To Adam Iskander- Senior Planning Officer, DPE
Planning Proposal PP-2021-5837 Western Sydney
Subject University Campus, Milperra – Response to Item 2 email dated 1
March 2023
Date 13 April 2023
From Theo Zotos- Senior Development Manager, Mirvac

Response to Submissions: Planning Proposal 2021-5837 Milperra

Figure 4 – Revised Basin Layout & Overlay

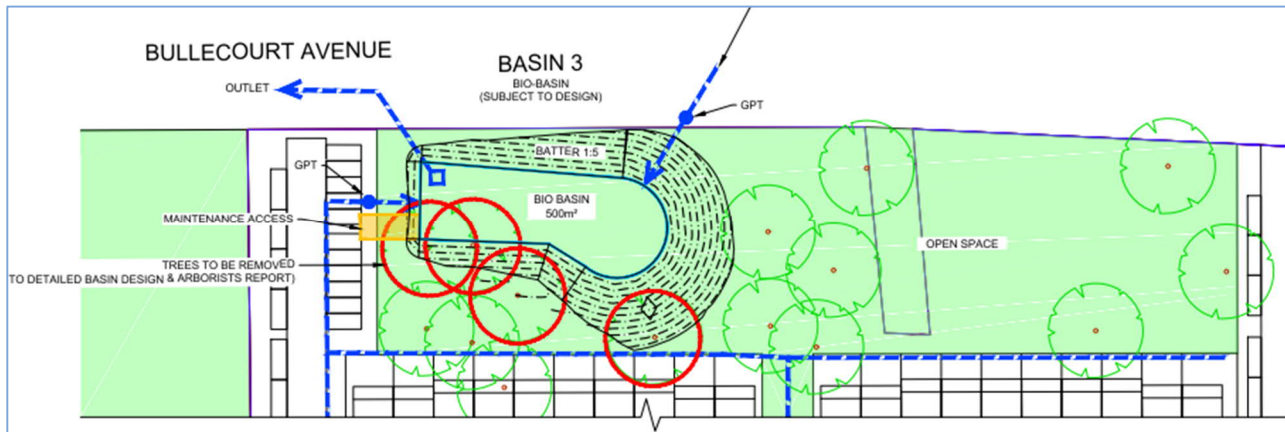
Since public exhibition, further detailed stormwater drainage analysis has been conducted (under the guidance of Council) with the aim to consolidate the proposed stormwater detention and water quality measures.

A particular focus of the drainage analysis was to reduce the footprint of the proposed drainage facility proposed within the northern open space located adjacent to Bullecourt Avenue. Refer to Figure 1 for site area identification.

A breakdown of the additional trees to be retained due to the revised drainage layout are listed in Table 1 below.

In terms of the impact of removing the vegetation in question, the landscaped setting in the northern portion of the masterplan is improved from that shown in the planning proposal placed on public exhibition. This is due to a focused redesign of the drainage facility contained within the northern open space which allows for the retention of between 17 mature trees located immediately north of the vegetated area in question.

Figure 3 Extent of canopy 1951, 1978 and current aerial image

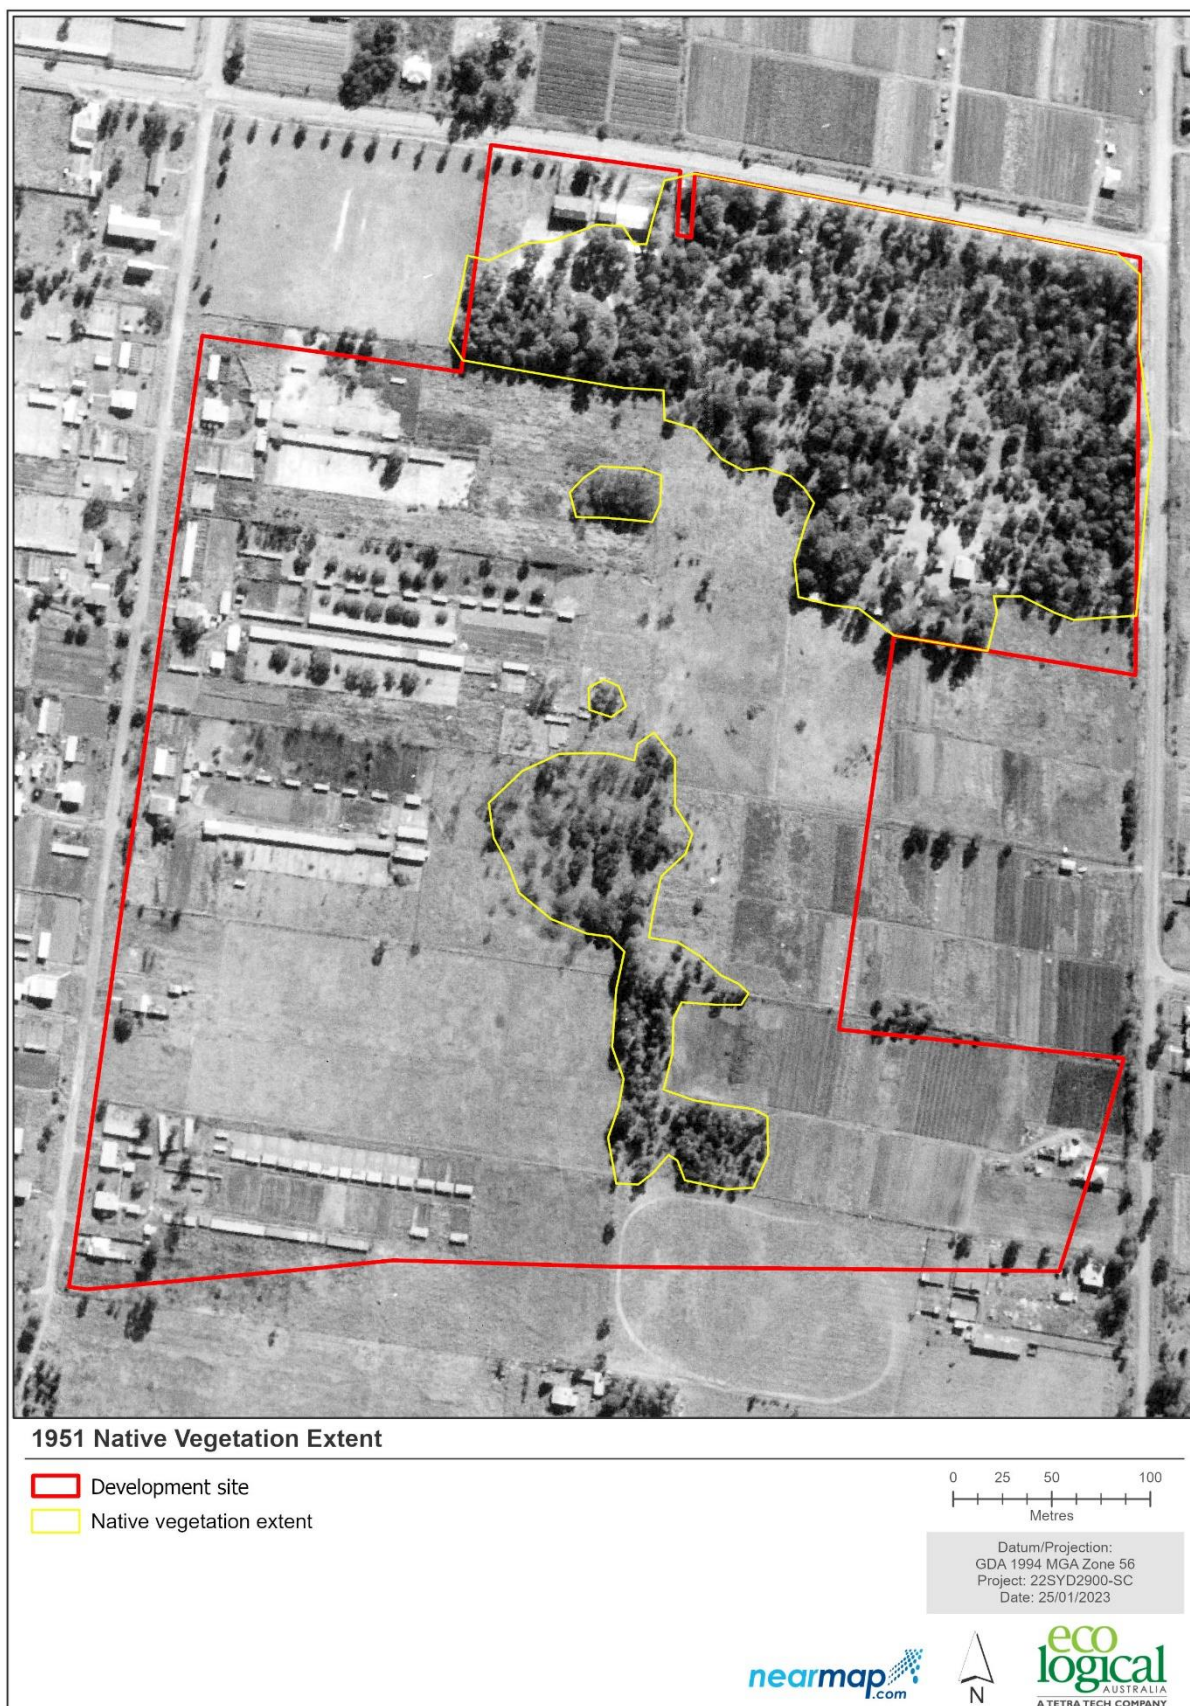
- A review of the historical aerals from 1951 and 1978 indicates that the extent of native vegetation at that time covers most of the area in question (refer to area which includes tree no's 58,62,63 and 199 outlined in Attachment 1). However, many trees in the photographs provided are small in size and are unlikely to be "remnant"; and either grown since the majority of the rest of the vegetation was cleared sometime after 1978 or have been planted.

Issue	EHG Recommendation	ELA comment
Biodiversity	All attempts are made to avoid all impacts to CPW at the site	The BDAR prepared by ELA currently shows the CPW in good and low condition (ie the remnant CPW) being protected – other than an impact to 0.3 ha. 0.55 ha of CPW in ‘landscape’ condition is being impacted. To protect this vegetation would require changes to the cut and fill balance such that there is no cut or fill in the Tree Protection Zones of trees that were mapped a CPW – Landscape.
Biodiversity Values Map	That areas on the Biodiversity Values Map will trigger the Biodiversity Offset Scheme	Noted. This is a matter for the DA stage.
Vegetation communities and threatened species	...the proposed structure plan for the site is amended to protect and conserve all existing remnant trees of CPW on the site and that the fragmented patches of CPW are actively managed and linked to improve the prospects of long term survival of the remnants and habitats on site	The EHG response implies that some areas mapped ‘CPW – Landscaped’ in the BDAR may actually be remnant vegetation. To determine if this is the case, ELA has mapped the extent of native vegetation on two historic aerial photos taken before and after development of the site (1951 and 1978). The aerial photos show that there is an area in the north of the site which has had tree canopy from at least 1951 and could therefore potentially be remnant. See Figure 1-3 below. However the Geotechnical report borehole logs show that this area in the north of the site has fill of approximately 0.6 metres (see

Issue	EHG Recommendation	ELA comment
		<p>extract in figure 4), which was most likely placed during development of the site. The trees are unlikely to be remnant if they have been subject to earthworks and filling. Further, the vegetation in the 1978 photo shows trees in a linear arrangement and current photos demonstrate they sit within an exotic lawn that has been maintained such that there is no understory or midstory in this area. See figure 5 below.</p> <p>ELA therefore believes that the use of a 'landscaped' (i.e planted) vegetation zone is appropriate and should not be changed in the BDAR. The impacts to the vegetation in this zone are being offset in accordance with the BAM.</p> <p>With regard to linking to other vegetation, we note that there is very little opportunity to link to vegetation off site as surrounding land is dense urban development of roads and housing.</p>
	<p><i>Acacia pubescens</i>: EHG previously advised that as the PEA reports a decline in the population size avoidance of impacts to this population should be a priority for the planning proposal.</p>	<p>The impacts to this species have been assumed due to the loss of two trees (3 and 7) in the east of the site. Depending on the extent of works in this location, it may be possible to avoid impacts to this species. We recommend that the RTS state that detailed design of construction will occur at the DA stage and will attempt to avoid impacts to this species habitat.</p> <p>For context: the species polygon for <i>Acacia pubescens</i> is 1.95 ha. The impact to 0.02 ha of this species polygon represents 4% of the extent of this species habitat on the site.</p>

Figure 4 Extract from Geotechnical report

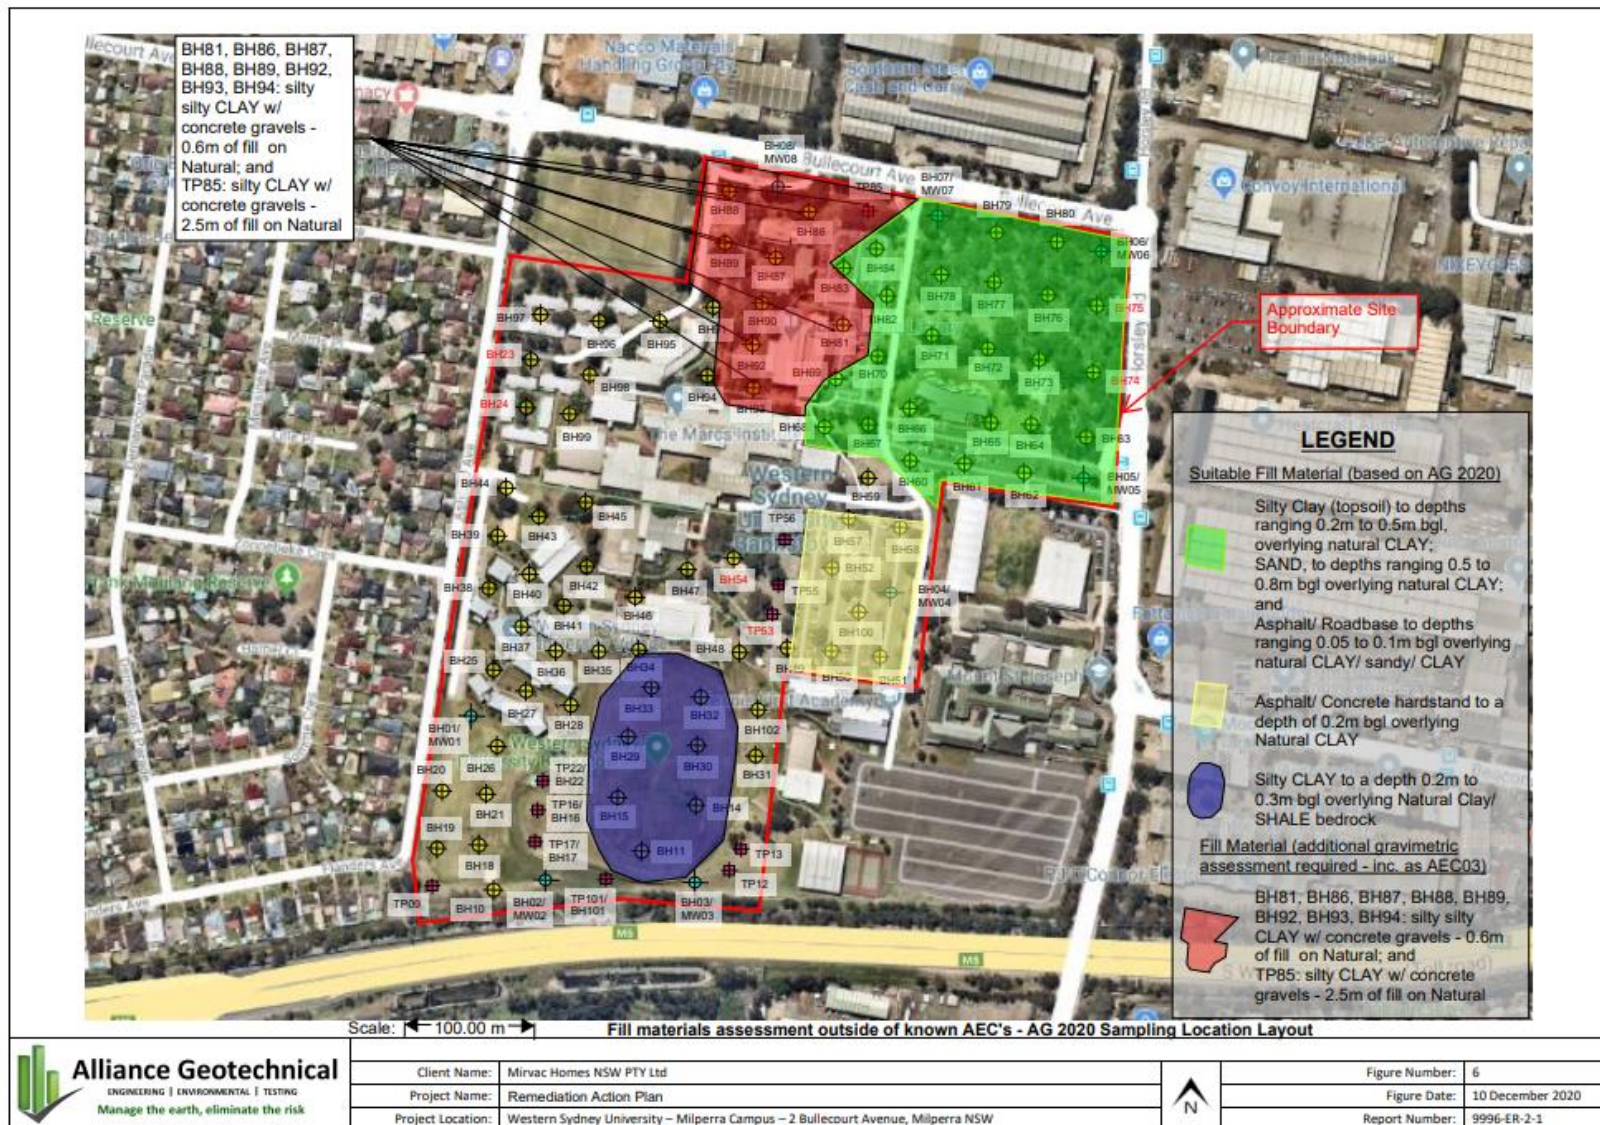
- The geotechnical report borehole logs (included in the attached EA letter) show that this area has fill of at least 0.6 metres while an adjacent area shows filling of over 2m. The fill which creates the existing landform was most likely placed during the development of the site over the decades.
